STRUCTURAL REPORT

**OFFICE BUILDING
249 MADRAS STREET**

CANTERBURY REGIONAL COUNCIL

January 1990

Sketch 3608/SK1

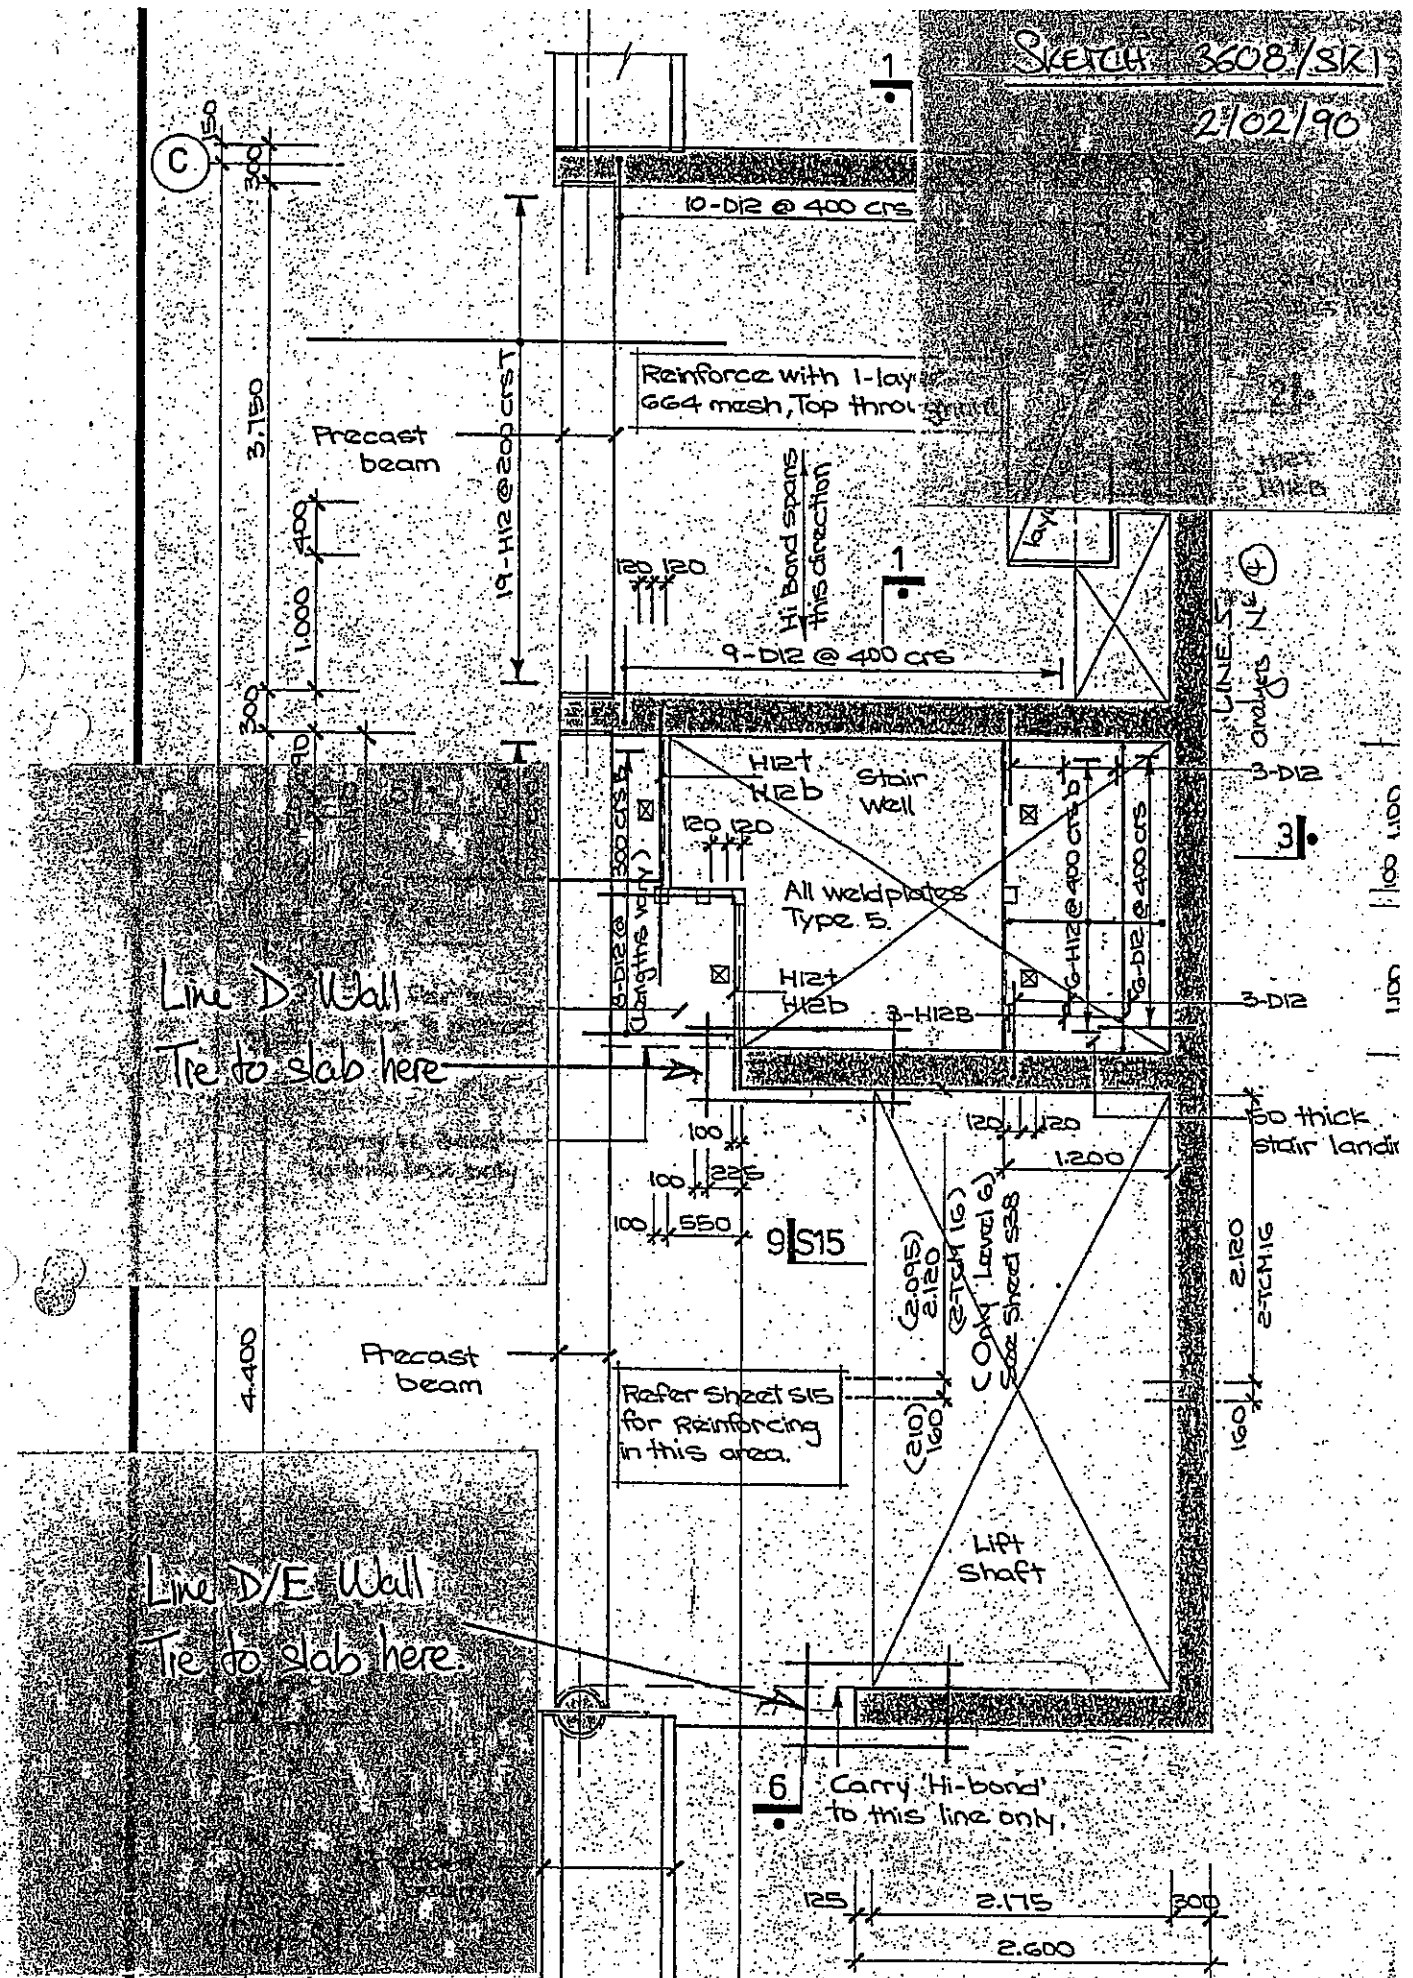
Further to our discussions by telephone this morning, we confirm that the scope of the possible non-compliance referred to in your report on the building is the connections between the walls on gridlines D and D/E, as shown on the attached sketch SK1 from levels 2 to 6 inclusive (Level 1 being the ground floor carpark).

The proposed remedial work, if required, would consist of a total of two ties per floor, tying the walls to the floor diaphragm.

The agreed maximum tie load is 300 kN per tie. We understand that this load would be reduced on lower floors in accordance with the "Parts and Portions" section of NZS 4203:1984.

WALL TIE TO SLAB. GRID LINES D, 4/5
LEVELS 4-6.

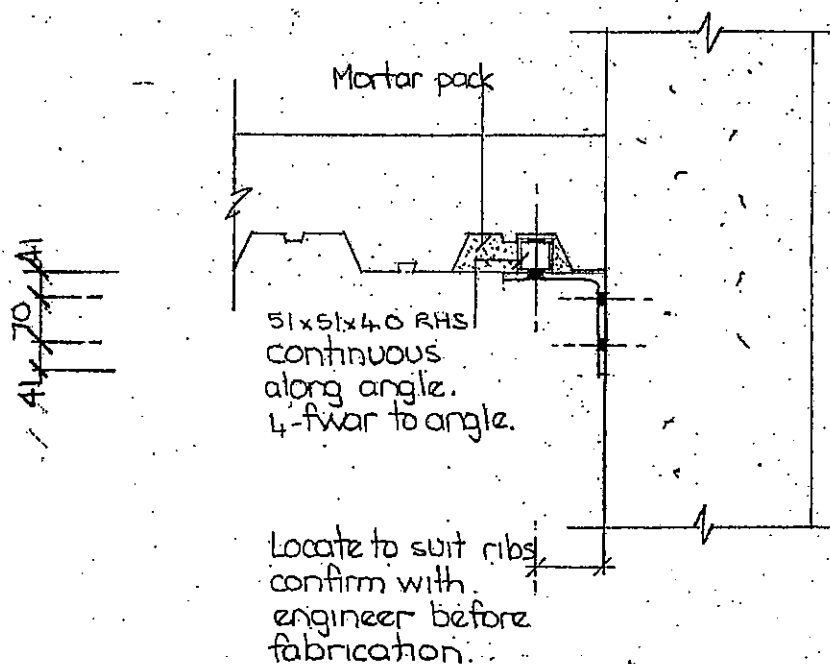
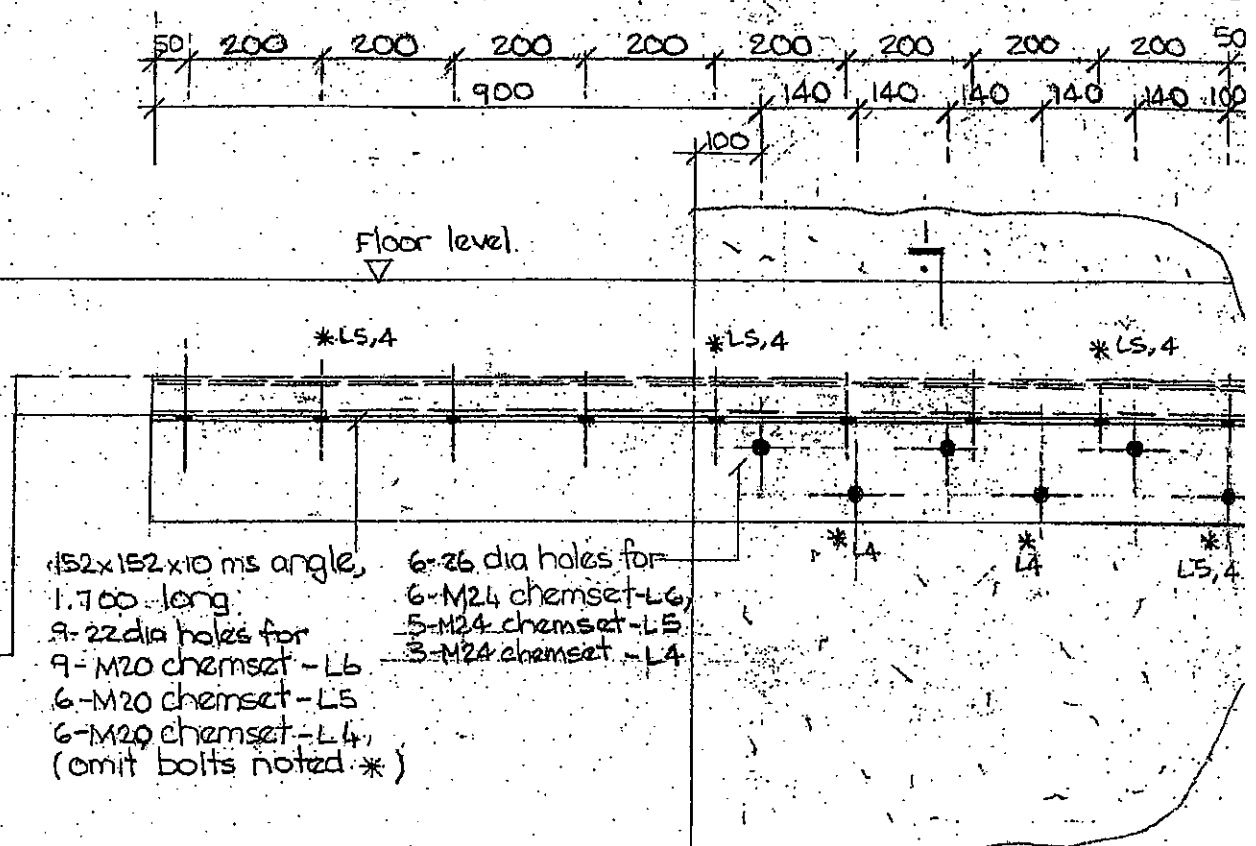
As discussed with you yesterday, we confirm that we wish to install a structural steel angle in the lift shaft at levels 6, 5, and 4, as shown on the attached sketches 3608/CD1, 2, 3. The angle is a structural tie only, and is not supporting any additional services.

I confirm that the details as shown on
sketches 3608/CD1, 2, and 3 are acceptable.
